COUNTY OF LETHBRIDGE NO. 26
IN THE PROVINCE OF ALBERTA
BY-LAW NO. 831

A BY-LAW OF THE COUNTY OF LETHBRIDGE NO. 26 IN THE PROVINCE OF ALBERTA TO ADOPT AN AREA STRUCTURE PLAN FOR THE DORAM HEIGHTS SUBDIVISION.

RE: Doram Heights Area Structure Plan

DORAM HEIGHTS

MAP #6

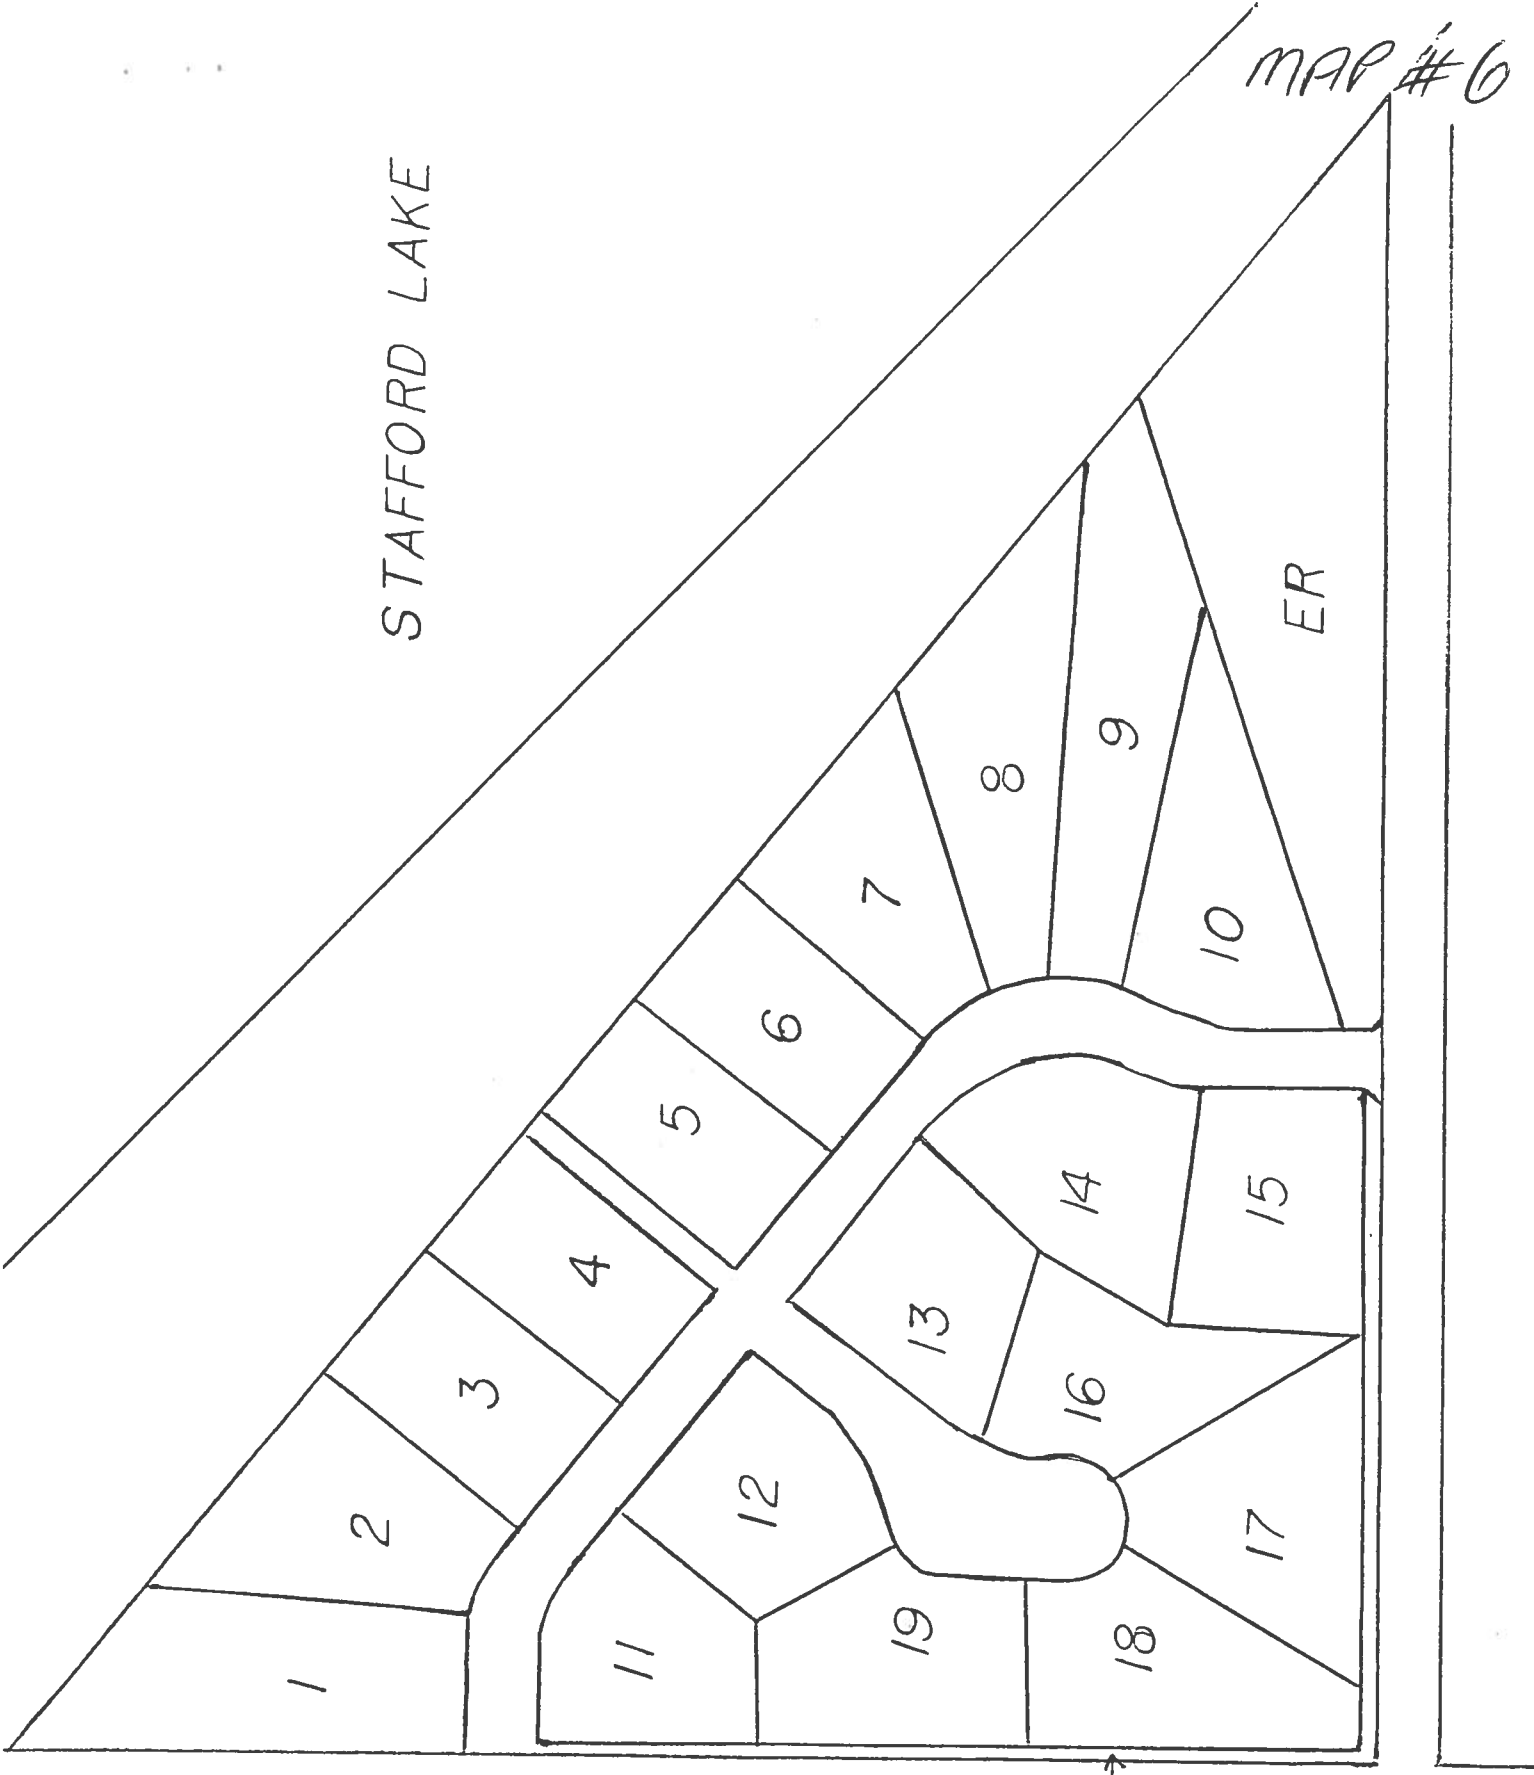
- A. Page 6: Wording has been updated to include the correct name of the zone (GC-R) and the definition of that zone.
- B. Map #6: is replaced by the revised Map#6 depicting 19 lots.
- C. Page 16: adjustment as to revised lot size and number. (Section 4.5)
- D. Page 17: additional information relative to revised lot sizes.
- E. Page 19: expanded description of architectural controls. (Section 5.2.4)
- F. Page 20: expanded description of plans for refuse collection (Section 5.2.6)
 - : new section 5.2.8 describing planned fire protection system, expanded to include proposed subdivision of portion of adjacent lands to contain reservoir.

The development plan has been revised considerably to now include 19 lots of an average size of 1.15 acres.

In addition MAP NUMBER 6 is replaced by the new MAP NUMBER 6 dated May 27, 1986 and attached.
